Access Compliance Report

Public Rights-of-Way

(Curb Ramps)

Intersection ID: 10123	Main Street: GLENWOOD_DR	Cross Street: TUCKASEEGEE_RD	Location: SE
ADA ID: 99D8D87C6266	Ramp Type: Directional1	Initial Pass/Fail: Fail	Overall Compliance: No
Codes/Mitigation Info/Possible Solution			Severity Score: 25
			Field Measurements/Component Compliance

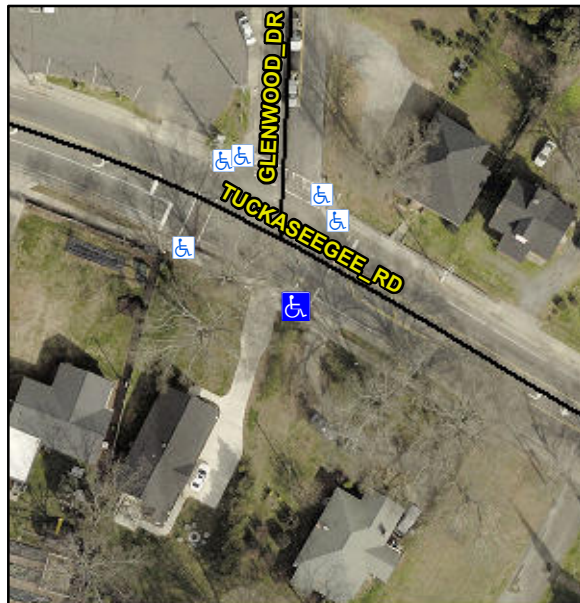
PONDING ON RAMP

R304.2.2

Compliance	Description	Data	Compliance	Description	Data
N/A	Ramp Length (in)	52.0	N/A	Grade Break?	N/A
Yes	Ramp Width (in)	48.0	N/A	Grade Break Slope (%)	0.0
No	Ramp Slope (%)	13.4	N/A	Grade Break XSlope (%)	0.0
Yes	Ramp XSlope (%)	1.5			
N/A	Flare Type LT	N/A	N/A	Flare Type RT	N/A
N/A	Flare Slope LT (%)	N/A	N/A	Flare Slope RT (%)	0.0
N/A	Flare Traversable LT?	N/A	N/A	Flare Traversable RT?	N/A
N/A	Landing Length (in)	0.0	N/A	DWS Provided?	N/A
N/A	Landing Width (in)	0.0	N/A	DWS Contrast?	N/A
N/A	Landing Slope (%)	0.0	N/A	DWS Length (in)	N/A
N/A	Landing X Slope (%)	0.0	N/A	DWS Full Width?	N/A
N/A	Landing Curb? (Y/N)	N/A	N/A	DWS Offset LT (in)	N/A
N/A	Shared Landing?	N/A	N/A	DWS Offset RT (in)	N/A
N/A	Gutter Ponding?	Yes	N/A	Gutter Slope (%)	N/A
N/A	Gutter Lip Ht (in)	0.0	N/A	Gutter X Slope (%)	N/A
N/A	Painted X Walk1?	Yes		Road Slope (%)	7.4
	X Walk 1 Direction	To N		Road X Slope (%)	0.9
	X Walk 1 Width (in)	114.0		Clear Space?	N/A

Remove & Replace Entire Ramp.
